Access Compliance Report

Public Rights-of-Way

(Curb Ramps)

Intersection ID: 2910	Main Street: RIDGEFIELD_DR	Cross Street: SWANSTON_DR	Location: NE
ADA ID: 438F98DC10CB	Ramp Type: PerpDiag	Initial Pass/Fail: Fail	Overall Compliance: No
			Severity Score: 21.25

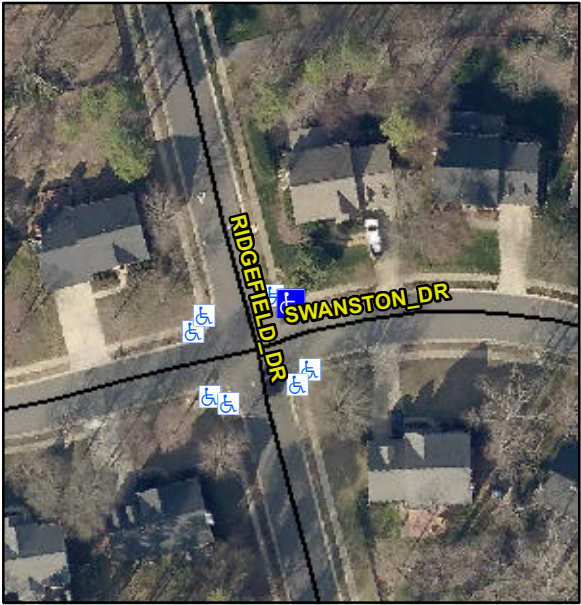
Codes/Mitigation Info/Possible Solution		Field Measurements/Component Compliance					
	Possible Solutions:	Compliance	Description	Data	Compliance	Description	Data
	Remove & Replace Curb Ramp With Two New Directional Ramps or Equivalent.	N/A	Ramp Length (in)	46.5	Yes	Ramp Slope (%)	7.6
		No	Ramp Width (in)	43.5	No	Ramp XSlope (%)	5.4
		N/A	Flare Type LT	N/A	N/A	Flare Type RT	N/A
		N/A	Flare Slope LT (%)	N/A	N/A	Flare Slope RT (%)	N/A
		N/A	Flare Traversable LT?	N/A	N/A	Flare Traversable RT?	N/A
		N/A	Landing Length (in)	N/A	N/A	DWS Provided?	N/A
		N/A	Landing Width (in)	N/A	N/A	DWS Contrast?	N/A
		N/A	Landing Slope (%)	N/A	N/A	DWS Length (in)	N/A
		N/A	Landing X Slope (%)	N/A	N/A	DWS Full Width?	N/A
		N/A	Landing Curb? (Y/N)	N/A	N/A	DWS Offset (in)	N/A
		N/A	Shared Landing?	N/A			
		N/A	Gutter Ponding?	N/A	N/A	Gutter Slope (%)	N/A
		N/A	Gutter Lip Ht (in)	N/A	N/A	Gutter X Slope (%)	N/A
		N/A	Painted X Walk1?	No	N/A	Painted X Walk2?	No

X Walk 1 Direction	To W		X Walk 2 Direction	To S
		N/A	X Walk 1 Width (in)	N/A	N/A	X Walk 2 Width (in)	N/A
			X Walk 1 Slope (%)	8.8		X Walk 2 Slope (%)	3.1
			X Walk 1 X Slope (%)	2.2		X Walk 2 X Slope (%)	5.7
		N/A	Ramp inside XWalk1?	N/A	N/A	Ramp inside XWalk2?	N/A
<p>Surveyor Notes:</p> <p>N/A</p> <p>PROW/ADA:</p> <p>R304.5.1, R304.5.3</p>			Road Slope (%)	1.7	N/A	Clear Space?	N/A
			Road X Slope (%)	6.0	N/A	Clear Space to XWalk (in)	N/A
<p>Total Cost:</p> <p>\$ 3200.00</p>		N/A	Any Obstructions?	N/A	N/A	Storm Grate/Utility Hazard?	N/A
			Obstruction Type			Storm Grate/Utility Type	
				N/A			N/A
					Yes	Surface Condition? (G/P)	Good
